# Access Compliance Report

## Public Rights-of-Way

Intersection ID: 17126	Main Street: MISSION_HILLS_RD	Cross Street: TEABERRY_CT	Location: NW
ADA ID: 147070C9BA96	Ramp Type: PerpDiag	Initial Pass/Fail: Fail	Overall Compliance: No
Codes/Mitigation Info/Possible Solution		Field Measurements/Component Compliance	
Severity Score: 12.5

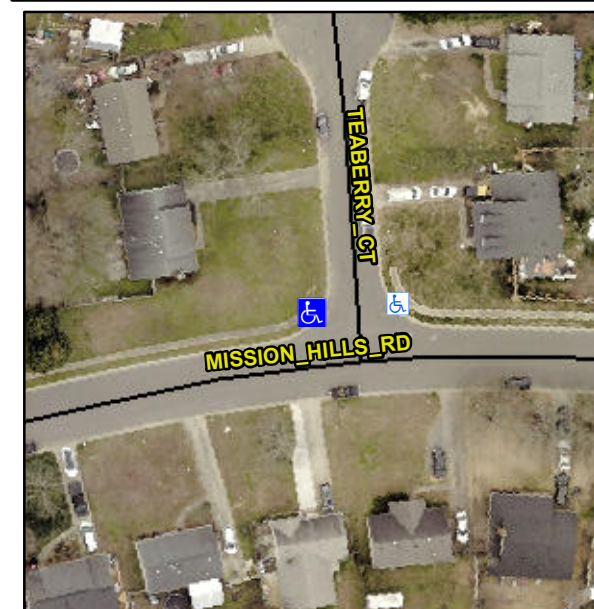
**Not Found, R304.2.2**

Compliance	Description	Data	Compliance	Description	Data
N/A	Ramp Length (in)	48.0	No	Ramp Slope (%)	9.0
Yes	Ramp Width (in)	48.0	Yes	Ramp XSlope (%)	1.9
N/A	Flare Type LT	N/A	N/A	Flare Type RT	N/A
N/A	Flare Slope LT (%)	N/A	N/A	Flare Slope RT (%)	N/A
N/A	Flare Traversable LT?	N/A	N/A	Flare Traversable RT?	N/A
N/A	Landing Length (in)	N/A	N/A	DWS Provided?	N/A
N/A	Landing Width (in)	N/A	N/A	DWS Contrast?	N/A
N/A	Landing Slope (%)	N/A	N/A	DWS Length (in)	N/A
N/A	Landing X Slope (%)	N/A	N/A	DWS Full Width?	N/A
N/A	Landing Curb? (Y/N)	N/A	N/A	DWS Offset (in)	N/A
N/A	Shared Landing?	N/A			
N/A	Gutter Ponding?	N/A	N/A	Gutter Slope (%)	N/A
N/A	Gutter Lip Ht (in)	N/A	N/A	Gutter X Slope (%)	N/A
N/A	Painted X Walk1?	No	N/A	Painted X Walk2?	No
	X Walk 1 Direction	To S		X Walk 2 Direction	To E
N/A	X Walk 1 Width (in)	N/A	N/A	X Walk 2 Width (in)	N/A
	X Walk 1 Slope (%)	1.9		X Walk 2 Slope (%)	1.1
	X Walk 1 X Slope (%)	1.0		X Walk 2 X Slope (%)	0.5

**Remove & Replace Curb Ramp With Two New Directional Ramps or Equivalent.**
